**EVALUATION AND PROFESSIONAL OPINIONS REGARDING
GEOLOGIC AND HYDROGEOLOGIC ASPECTS OF THE 2016
DRAFT ENVIRONMENTAL IMPACT STATEMENT AS IT
PERTAINS TO SCHEDULED FACILITY CLOSURE IN
2019 OR EXTENDING OPERATION UNTIL 2044**

**Navajo Generating Station –
Kayenta Mine Complex Project
Navajo Nation, Arizona, USA**

Groundwater Management Associates, Inc.
4300 Sapphire Court, Suite 100
Greenville, North Carolina 27834
Telephone: (252) 758-3310
gma-nc.com

JUNE 5, 2017

Figure 3: Layout of NGS Coal-Ash Disposal Site and Groundwater Monitoring Wells
 (Source: Modified from Figure 4, SRP, 2016b)

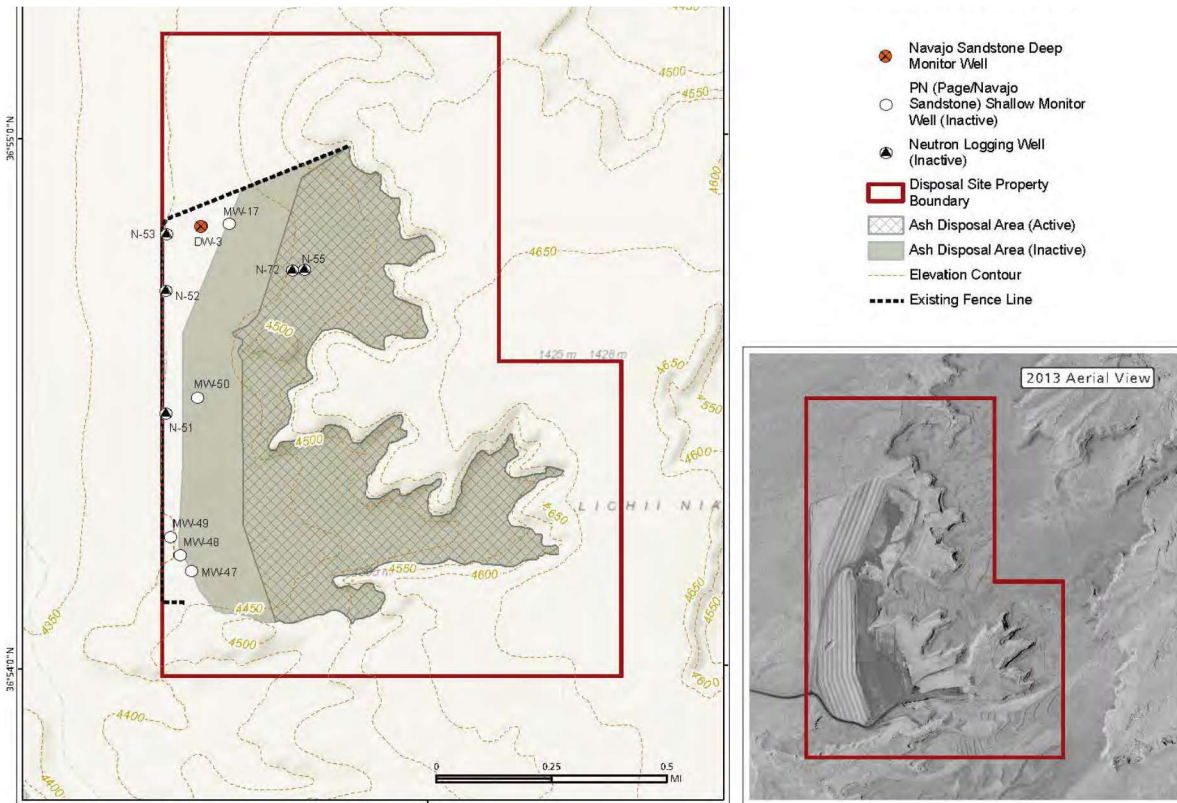
- Ongoing groundwater monitoring at the 400-acre coal ash landfill appears limited to the semi-annual sampling and testing of a single well in the N Aquifer (DW-3), and multiple shallow wells at the coal ash landfill are explicitly listed by SRP as “inactive” (Figure 3). Well DW-3 is located northwest of the ash retention dam, and the 2015 groundwater-flow (equipotential) map for the N Aquifer (Figure 12) indicates that well DW-3 is located hydraulically upgradient or side-gradient of the coal ash. Therefore, well DW-3 may not be located in a position that would allow impacts from the CCR landfill to be detected. The DEIS states that “A deep well groundwater monitoring system is being installed and groundwater samples are collected from the uppermost aquifer. This system will monitor both upgradient and downgradient groundwater quality to comply with CCR regulations by October 17, 2017.” (SRP, 2016b, page 1B-61). The DEIS does not include a more specific description of the planned coal ash monitoring-well network, or a revised sampling and analysis plan to address landfill monitoring (see Section IV.3 below).

- There is only one active monitoring well at the coal ash landfill, deep well DW-3, which taps the N Aquifer (Figure 3). Data provided in the DEIS indicate that DW-3 is being sampled and analyzed on a semi-annual basis for the following parameters: arsenic, barium, cadmium, chromium, fluoride, lead, selenium, sulfate, and TDS (SRP, 2016b, Table 10c, page 1B-166). The DEIS does not describe why those are the only parameters being targeted for analysis. The 2015 federal rules for coal ash landfill closure and monitoring identify many other constituents that occur in groundwater impacted by coal-ash leachate.

Figure 5: Distribution of Groundwater in the Carmel Formation beneath the NGS
 (Source: Figure 8, SRP, 2016b)

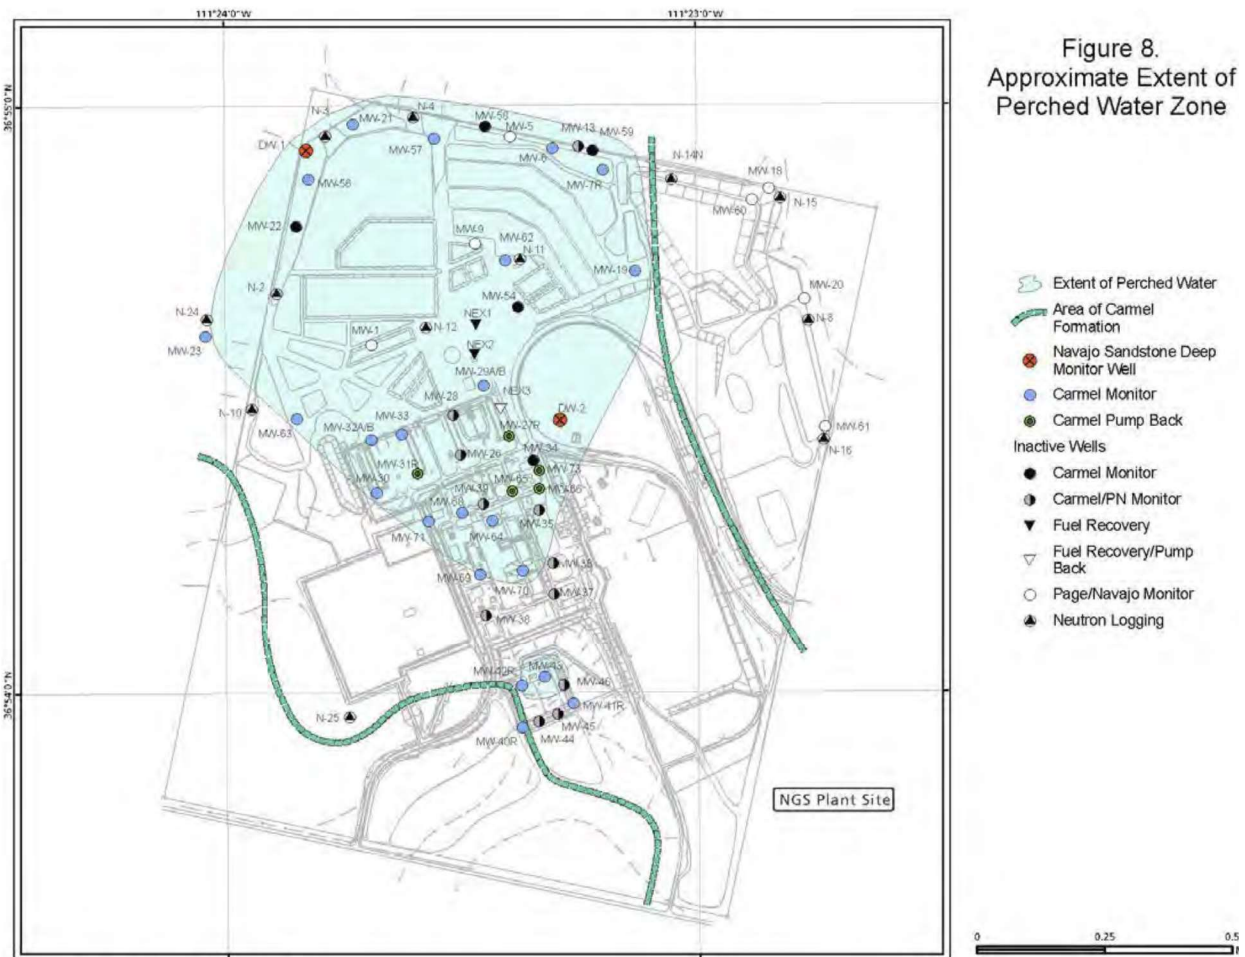
- In May of 2015, the depth to groundwater measured in 18 monitoring wells screened in the Carmel Formation averaged 13.4 feet below the land surface (BLS), and groundwater occurred less than five (5) feet BLS (SRP, Table 3, page 1B-230). SRP claims that Carmel groundwater has a limited extent directly beneath the NGS plant (Figure 5), yet much of this claimed distribution merely reflects the footprint of the monitoring-well network, and not necessarily the extents of groundwater. For example, the shallowest groundwater (4.7 feet BLS) was measured on the west side of the well network at MW-63, yet Figure 5 indicates that no groundwater is present immediately west of that well, which is extremely unlikely. In fact, it appears that most of the horizontal distribution of the groundwater in the Carmel Formation is undefined.

- In 2015, groundwater in the Carmel strata (Figure 5) was located an average of 13.4 feet below the surface at the NGS plant, and "*potential sources of the perched water include past seepage from the evaporation ponds, cooling towers, and previously unlined drainage ditches in the ash dewatering area*" (SRP, 2016b, page 1B-199). To combat this subsurface recharge by NGS industrial water containing "*elevated levels of TDS (total dissolved solids) and certain trace metals indicative of plant process water*", the SRP began pumping water from the Carmel Formation to "*capture and control possible migration of water*" (SRP, 2016b, page 1B-199). Ongoing pumping indicates that releases of industrial water persists at NGS.

Figure 7: Fractured Sandstone at the NGS Coal-Ash Disposal Site in April of 2015
 (Source: Modified from Google Earth)

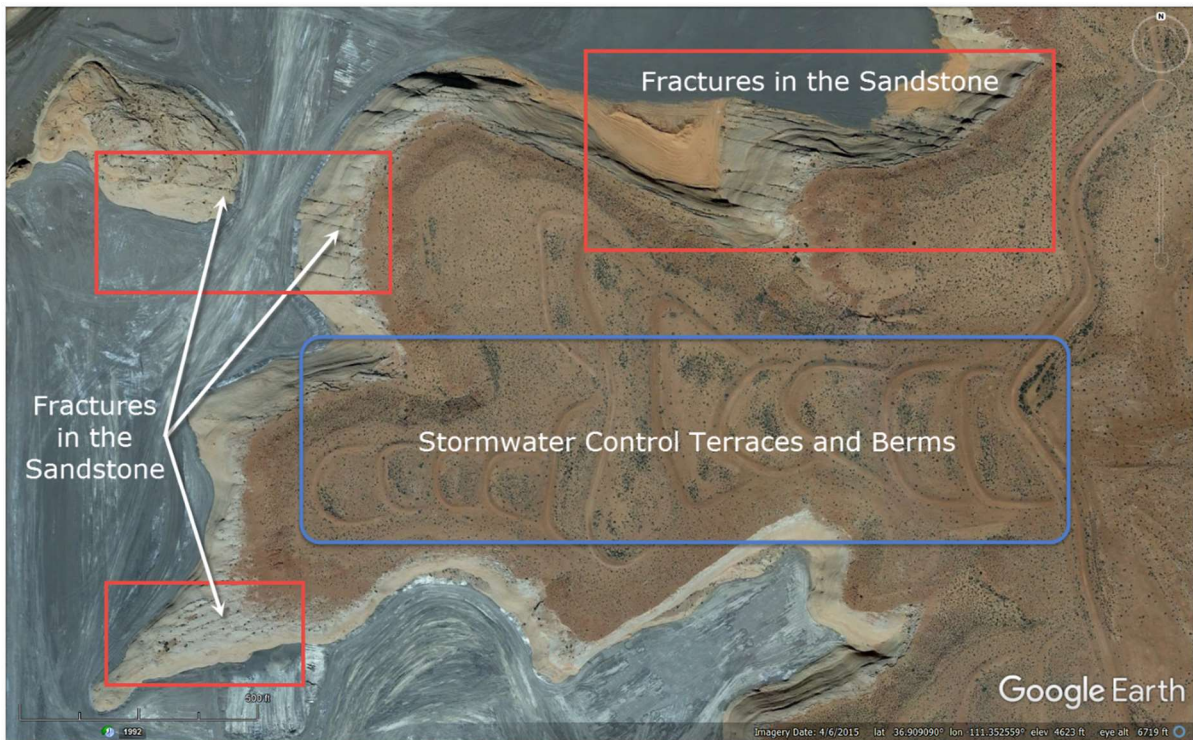
- The N Aquifer “is the principal source of industrial (Kayenta Mine) and municipal water in the study area” (SRP, 2016a, page 3.7-13). At the NGS plant, there is an average of approximately 870 feet of unsaturated Page Sandstone and Navajo Sandstone present between the bottom of the water-saturated Carmel strata and the top of the groundwater-saturated portion (water table) of the N Aquifer (Figure 6). In 2015, the depth to groundwater measured in the N Aquifer at monitoring well DW-1 located at the northwestern side of the NGS plant was 833 feet BLS (SRP, 2016b, Table 3, page 1B-231). Groundwater in the N Aquifer occurs in primary porosity located between individual sand grains and in fractures such as those readily visible at the coal ash disposal site where ash is in direct contact with the sandstone bedrock (Figure 7).

deposited directly upon fractured sandstone (Figure 7) or unconsolidated sand blanketing the sandstone, and no liner or low-permeability material such as compacted clay was installed prior to ash disposal. The DEIS reports that between 1978 and 1981, an estimated 127 to 293 Million gallons of "plant process water" was applied to the coal ash pile to "suppress dust" and to dispose of excess water, plus another 67 Million gallons of "plant process water" was applied to the coal ash pile in 1985 to facilitate water treatment repairs (SRP, 2016b, page 1B-213). A conservative annual average of approximately 70 Million gallons of precipitation falls directly on the 400 acres of coal ash each year. Collectively, it appears likely that more than 3 Billion gallons of water have been added to the surface of the disposed coal ash by natural or human actions since the NGS began producing and storing coal ash. Leachate and groundwater migration pathways through fractured rock are notoriously difficult to intercept or predict. SRP discovered this in 1987, six years after deep well DW-2 was installed, when "*water entering the open borehole below the surface casing via a fracture at 125 feet (caused) short-circuiting to the groundwater, causing a spike in TDS and sulfate levels.*" (SRP, 2016b, page 1B-203).

- SRP claims that *"the combination of existing and berms under construction limit as much run-on flow as is reasonable under site conditions"* (Haley & Aldrich, 2016c, page 1), but they do not state how or why less than full prevention of run-on flow is necessary or acceptable. Inspection of Figure 7 and Figure 14 appears to show numerous locations where stormwater run-on is likely to occur from the plateau forming the eastern side of the CCR landfill without intercepting any barrier or berm.

Figure 8: Projected Water Level Declines in the N Aquifer by Mining at the KMC
 (Source: Figure 3.7-12, SRP, 2016a)

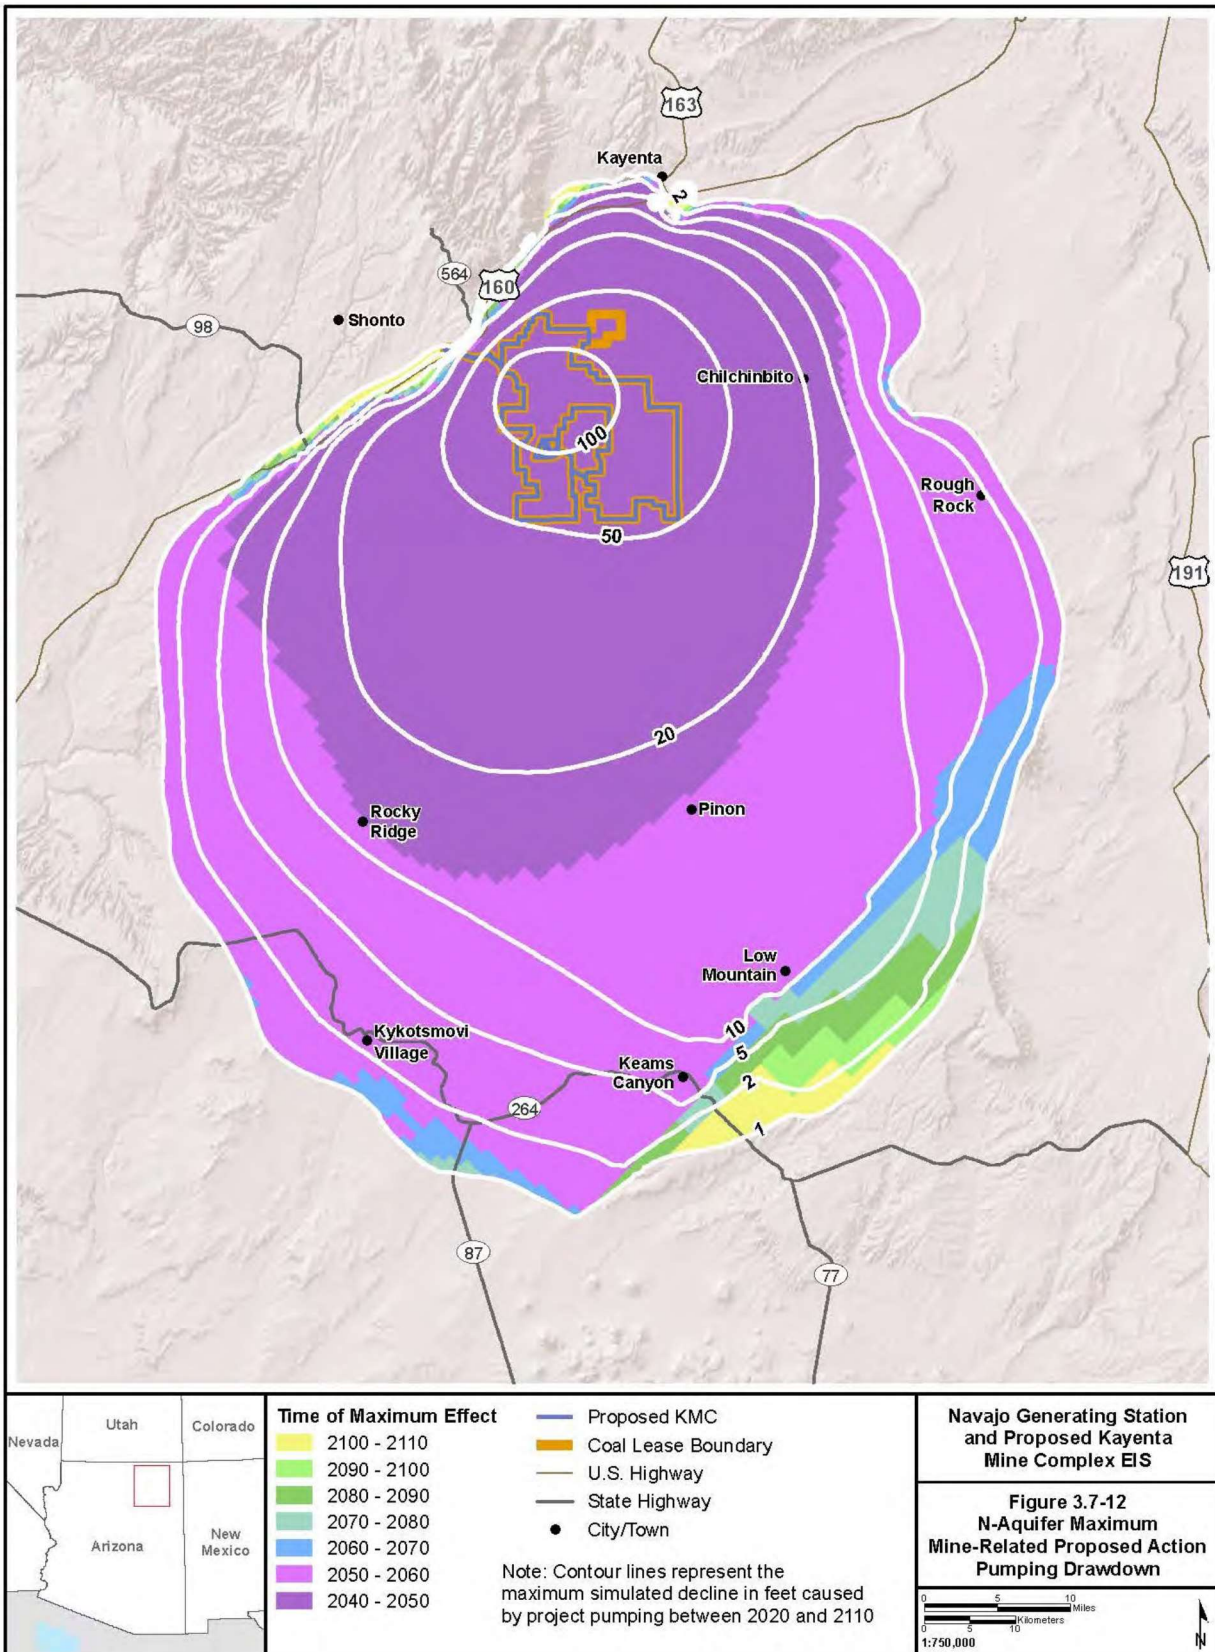
- The DEIS projects that KMC groundwater withdrawals from the N Aquifer will cause the water table to drop from more than 100 feet to a few feet for up to 55 miles away from the KMC (Figure 8). The assumptions and methods used in computer modeling of KMC groundwater withdrawals (SRP, 2016b, Appendices WR-9 and WR-10) have not been evaluated in connection with this expert report.

Figure 12: Groundwater-Flow Map for the N Aquifer at the NGS
 (Source: Figure 7c, SRP, 2016b)

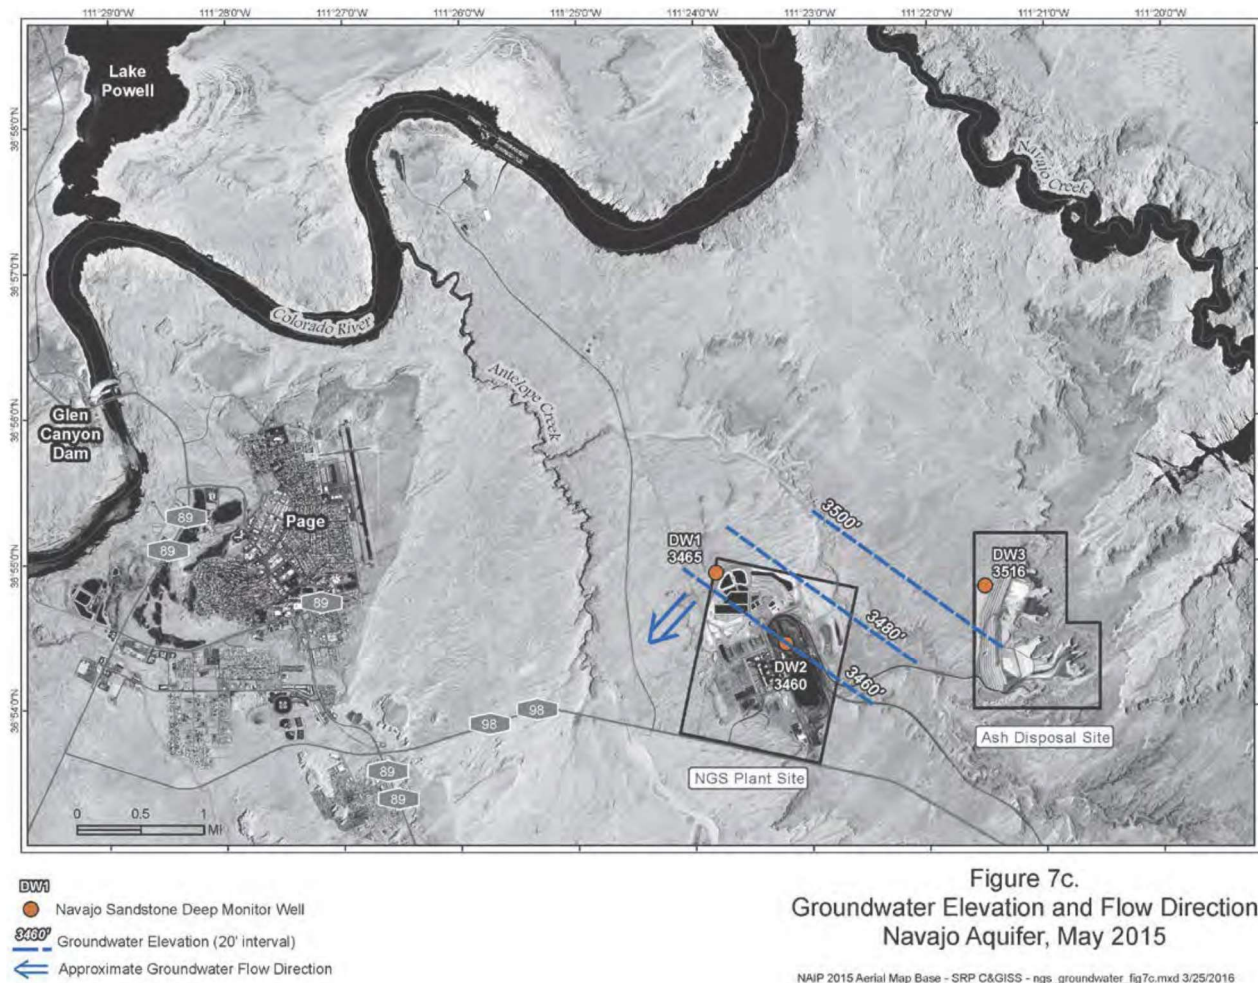
- Water quality in the N Aquifer is at risk from various surface contaminant sources, despite the roughly 870-foot separation between the ‘perched’ Carmel Formation groundwater and the top of the water table in the N Aquifer. Only three monitoring wells at the NGS penetrate the N Aquifer, wells DW-1 through DW-3 (Figure 12). These wells originally consisted of a pipe (casing) between the surface and 20 or 80 feet BLS, and an open borehole was drilled in the sandstone from the bottom of the pipe to 1,200 BLS (DW-1) or 1,500 feet BLS (DW-2 and DW-3). SRP attributed a “spike” in the concentrations of TDS and sulfate (SO₄) detected in well DW-2 beginning in about 1987 to be a result of the downward migration of NGS industrial-process water “perched” in the Carmel Formation via fractures in the underlying sandstone. Figure 7 shows large fractures in the sandstone that forms the sides of the unlined coal ash landfill. To try to eliminate further impacts to the N Aquifer, SRP installed a longer casing (liner) in well DW-2 to 660 feet BLS in 1989, followed by casing well DW-1 to 700 feet BLS in 2008, and casing well DW-3 to 750 feet BLS in 2015 (SRP, 20916b, page 1B-203). Time-concentration graphs for these three well (SRP, 2016b, Figures 10 through 12, pages 1B-256 to 1B-258) show trends in TDS and/or SO₄ that indicate impacts to N Aquifer water quality from NGS-leaked water and/or coal ash leachate migrating many hundreds of feet downward.

Figure 13: NGS Power Block Drainage Ditch and Ash Ditch
(Source: Figure 3, SRP, 2016b)

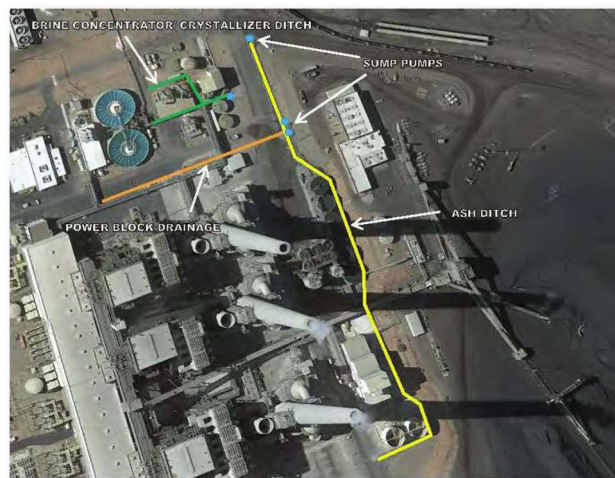
- Another source of coal ash-contaminated water at the NGS facility is the “Power Block Drain” that “collects drainage from the Unit 1, 2, and 3 bottom ash areas (and) includes: rainwater collected from concrete surfaces, bottom ash system washdown, bottom ash system leakage, and occasional upset-spillage from the bottom ash system and FGD slurry tanks” (SRP, 2016b, page 1B-150). That ash-laden water is directed into the “Ash Ditch”, which “collects and transports a mixture of service water and process water with a high concentration of solids” (SRP, 2016b, page 1B-150). It seems likely that leakage from the Power Block Drain and the Ash Ditch is responsible for at least some of the water accumulating as groundwater in the Carmel Formation.

Figure 14: Designated Run-on/Run-off Drainage Areas at the NGS CCR Landfill
 (Source: Modified from Figure 1, Haley & Aldrich, 2016c)

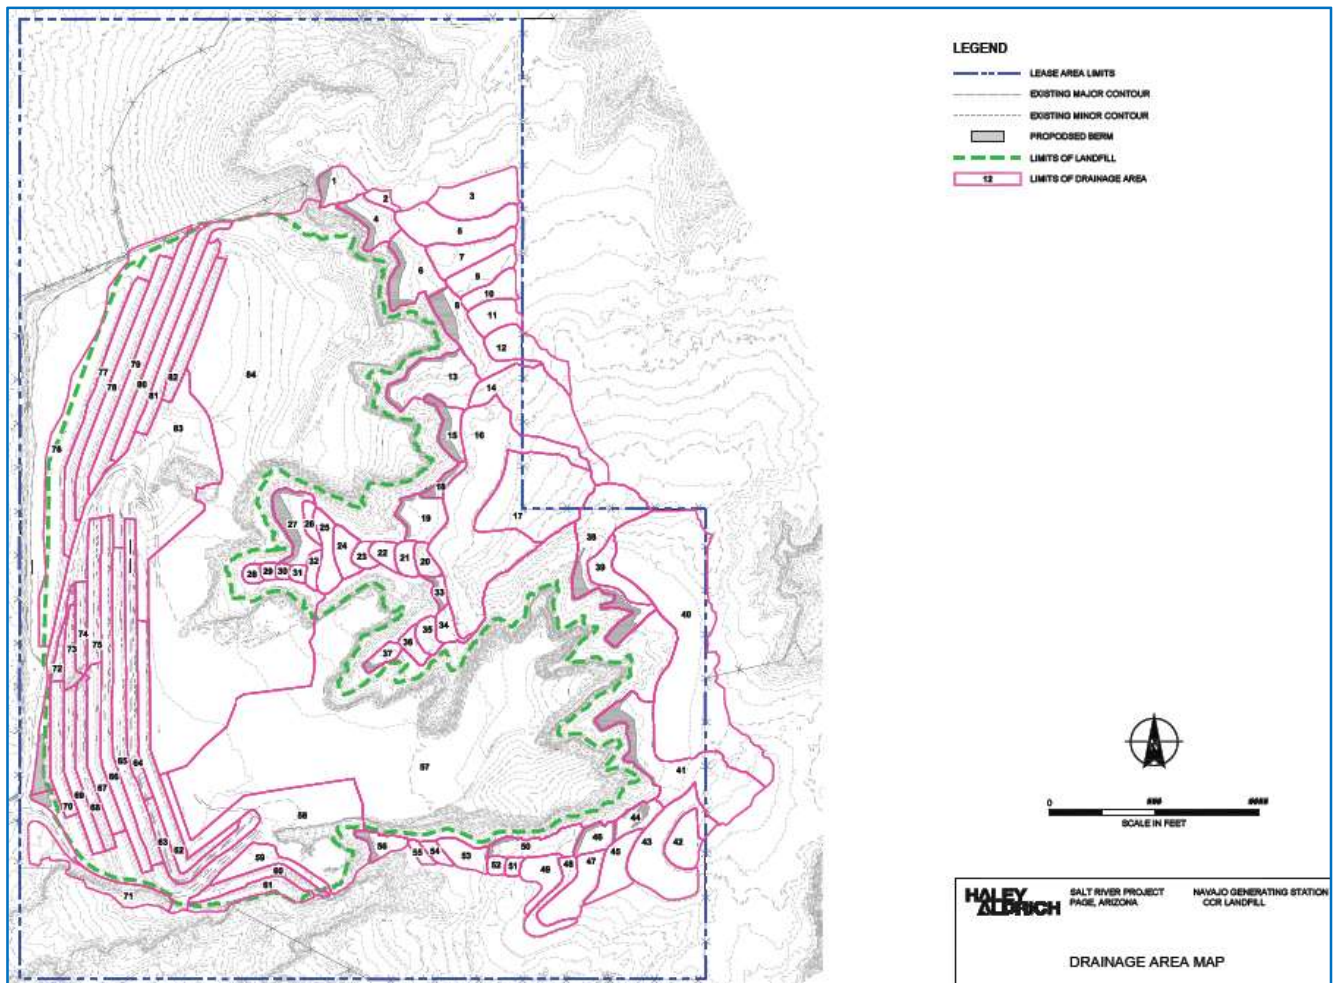
- Section §257.81 of the 2015 CCR Rule requires production of a stormwater "Run-on and Run-off Control Plan" to *"prevent flow onto the active portion of the CCR unit during the peak discharge from a 24-hour, 25-year storm"*(USEPA, 2015, §257.81(a)(1)). However, the current design (Haley & Aldrich, 2016c) falls short of the run-on control requirements for coal ash landfills.
